City of Chipley
Planning & Zoning Commission Meeting
November 19, 2026 at 3:00 PM
City Hall - 1442 Jackson Avenue, Chipley, FL 32428
AGENDA

1. **Request for Development Order** - Wal-Mart Stores East LP - 1621 Main Street

MEETING DATE	PREPARED BY
Thursday, November 19, 2026	Tamara Donjuan, Planning & Zoning Officer

Wal-Mart Stores East LP is requesting a development order for proposed expansion and renovations. This property is zoned Commercial and is within the Corridor Development District (CDD) overlay, which requires review and approval by the Planning and Zoning Commission and the City Council. The property is located at 1621 Main Street, Parcel ID: 00000000-00-2336-0000, 28.46 Acres.

SHEET: C1.4

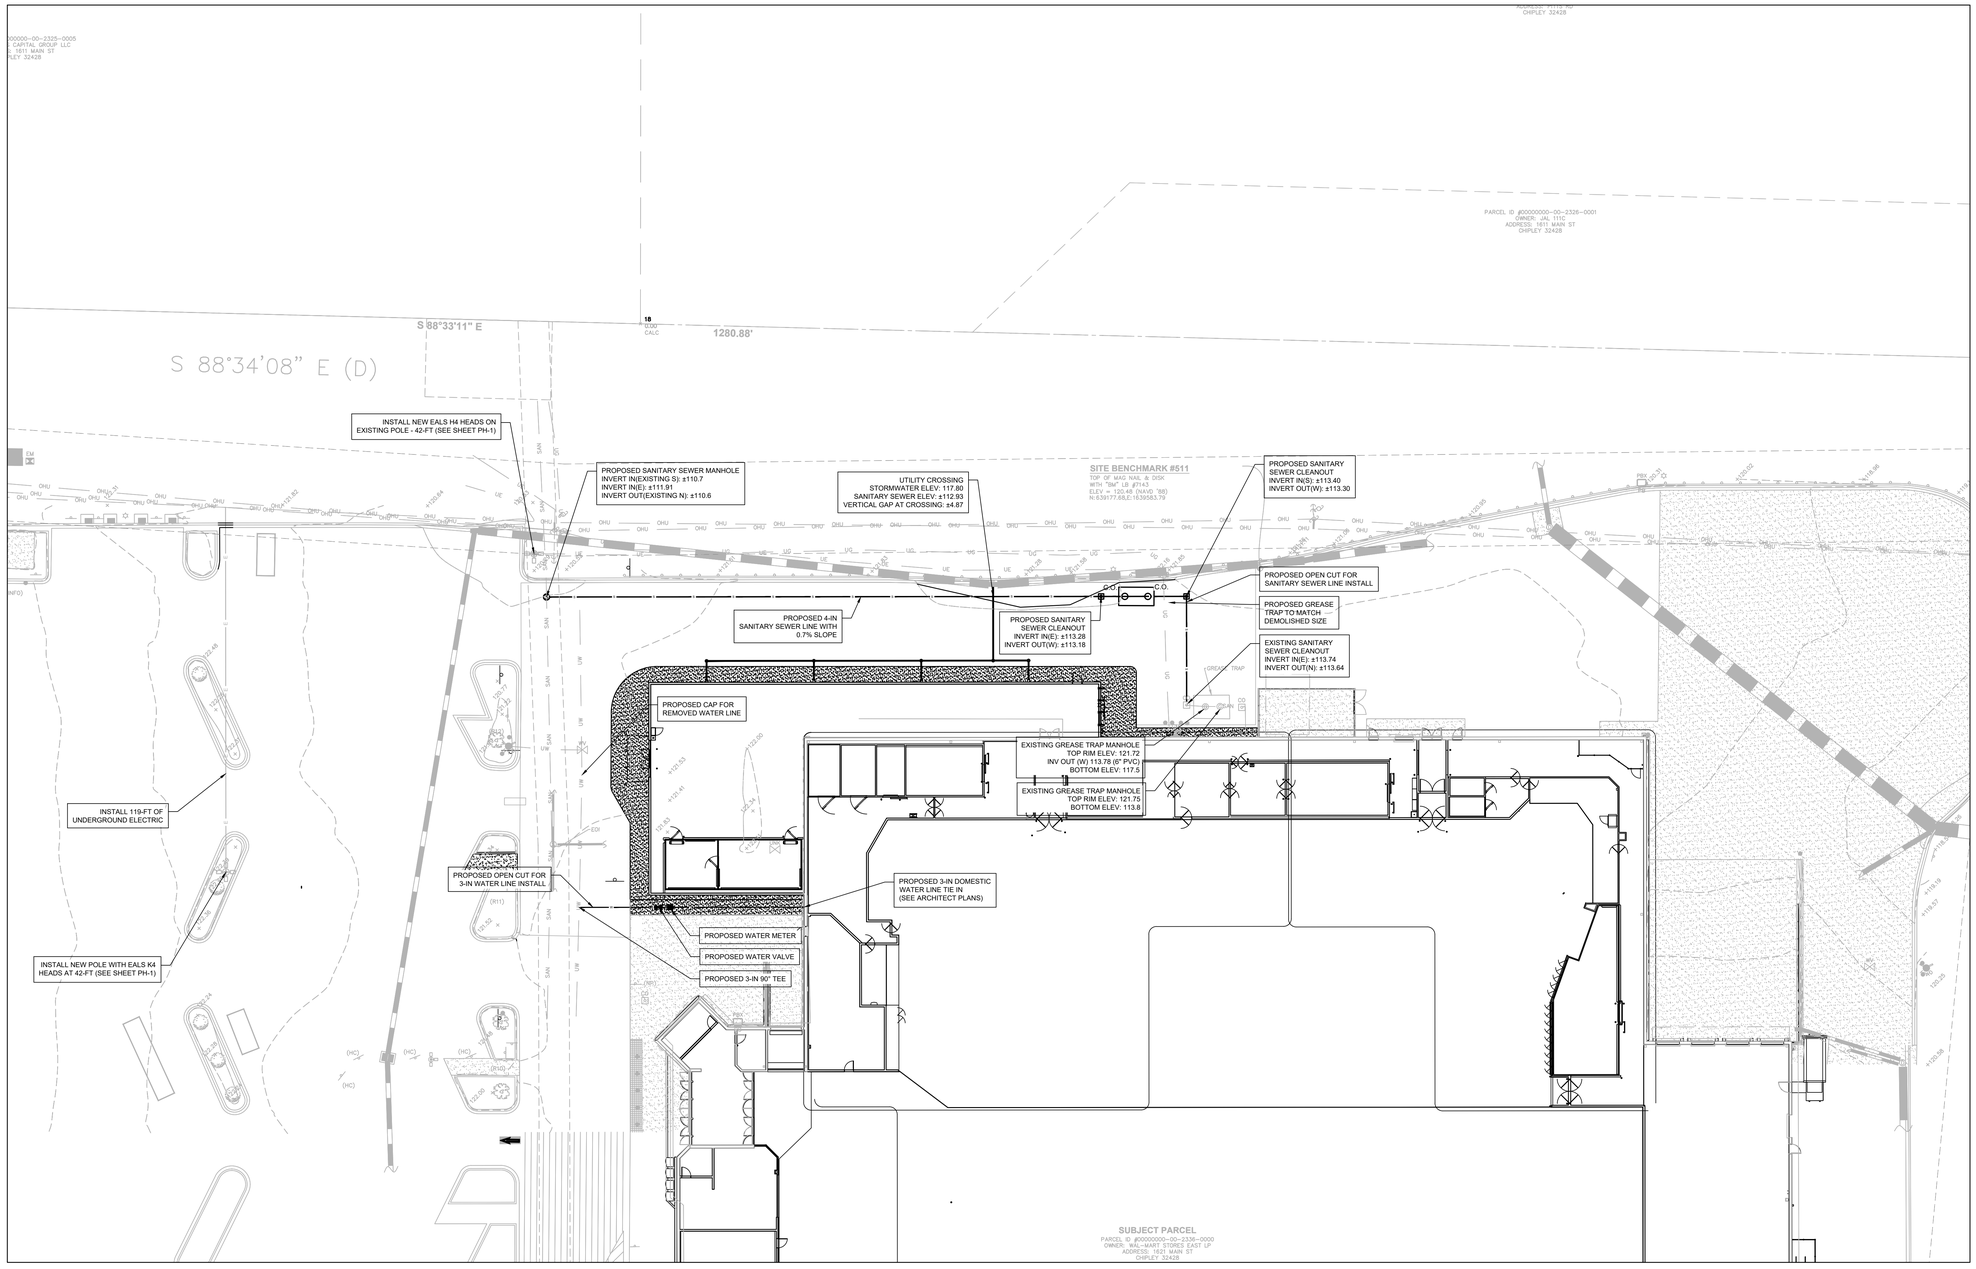
Sufficient: Provided in Plan Set: Sheets V1.2 & C1.4

SHEET: C1.5

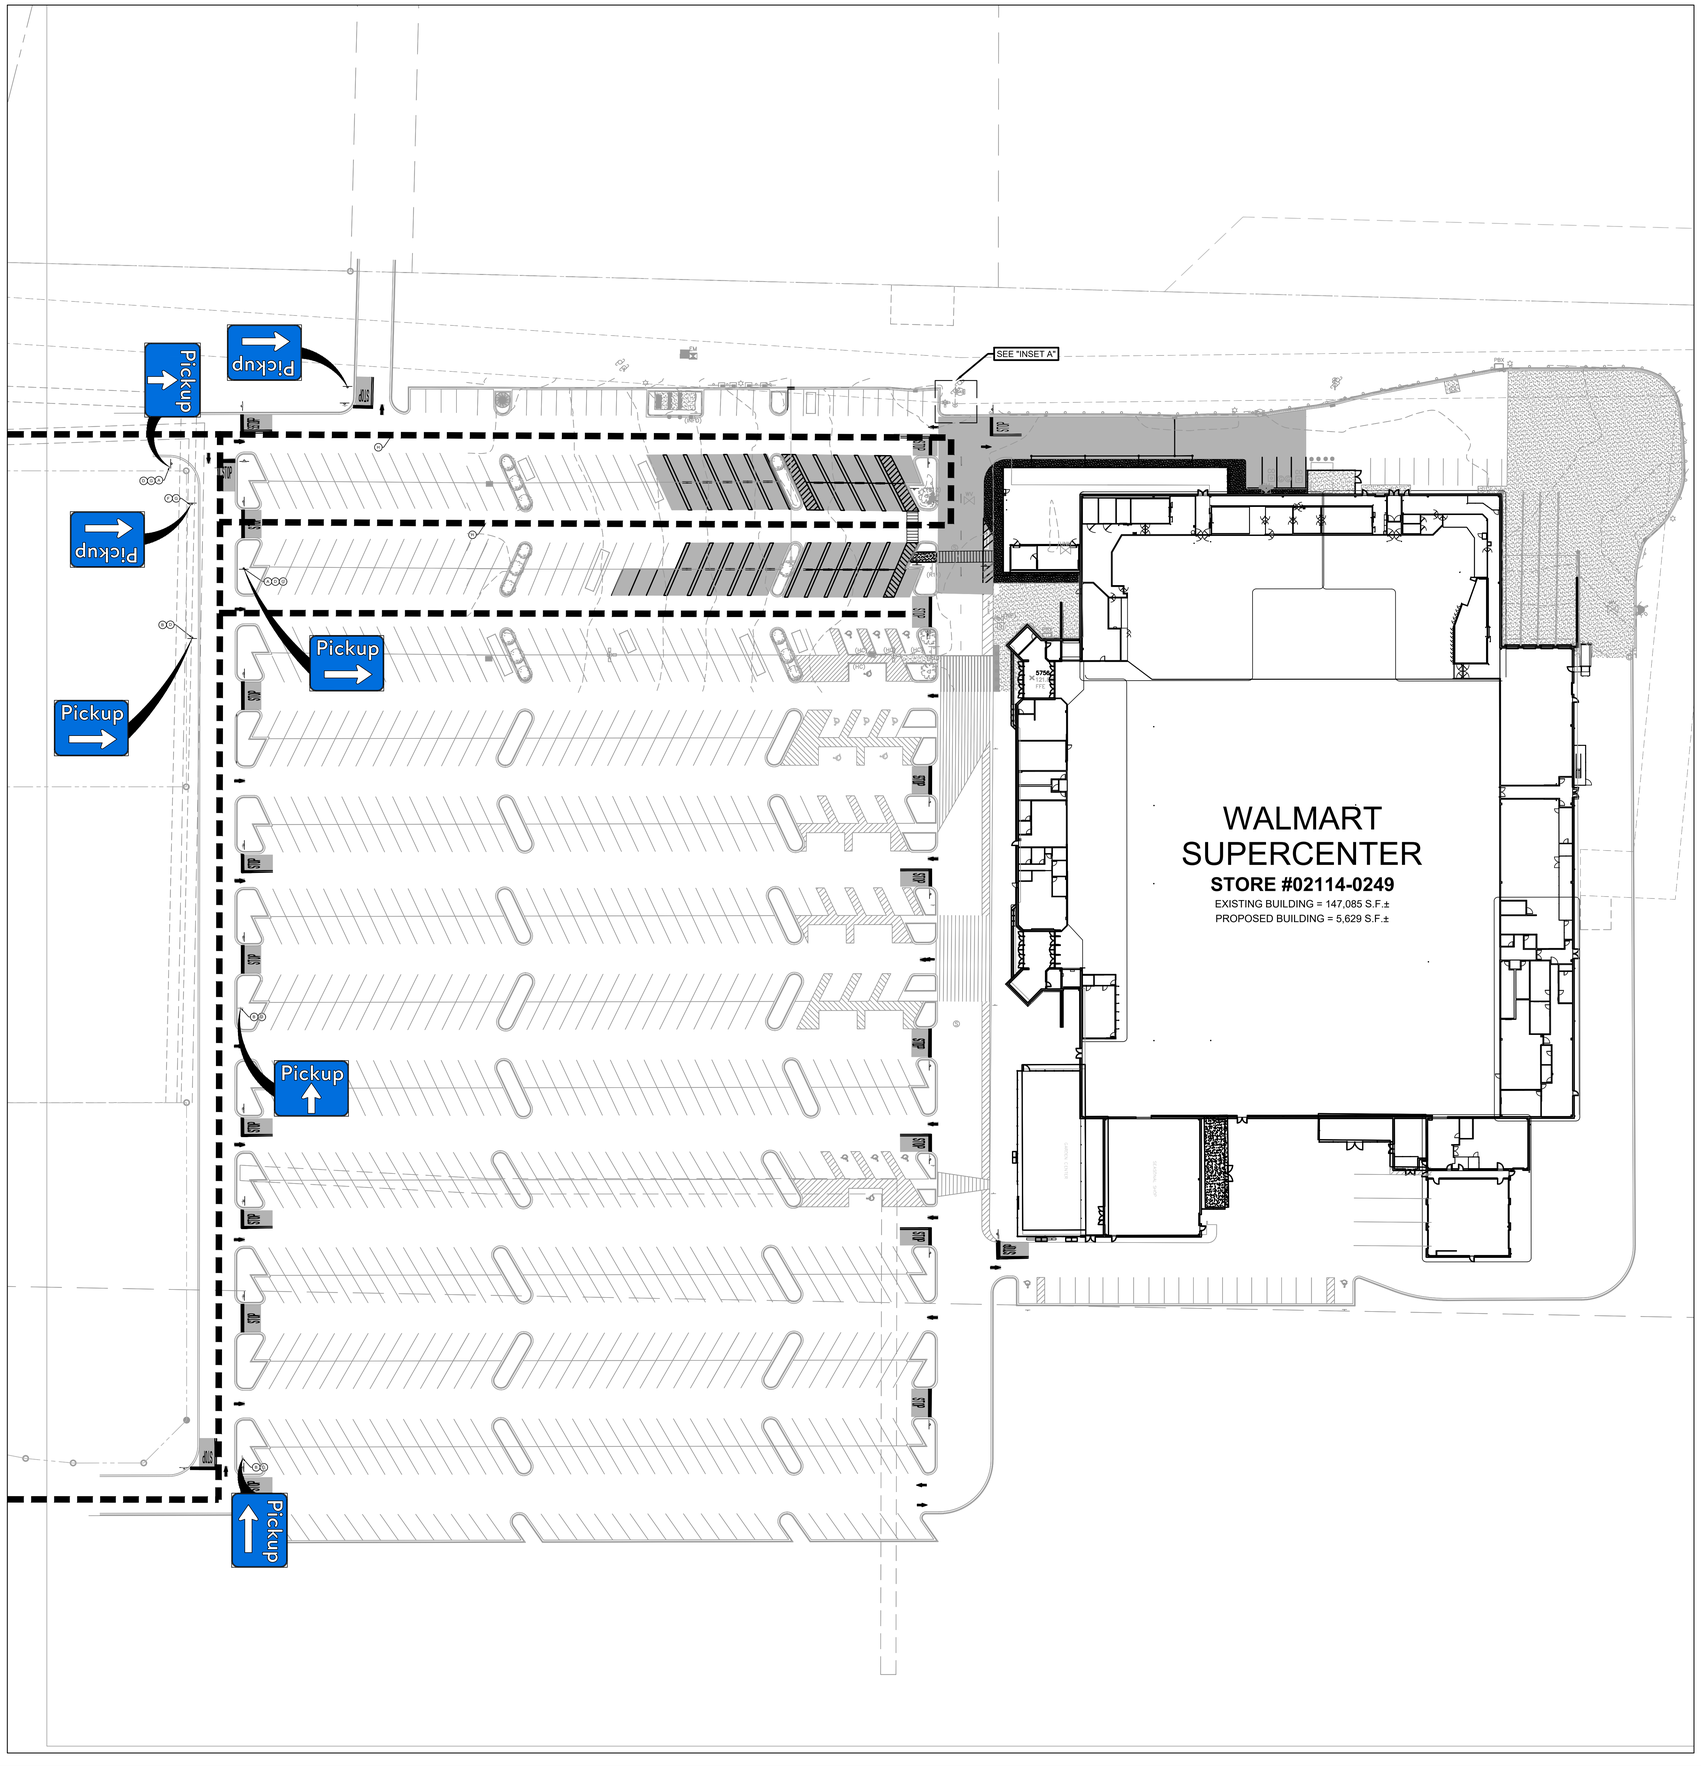
Sufficient: Provided in Plan Set: Sheet V1.1 & V1.2 & C1.5.
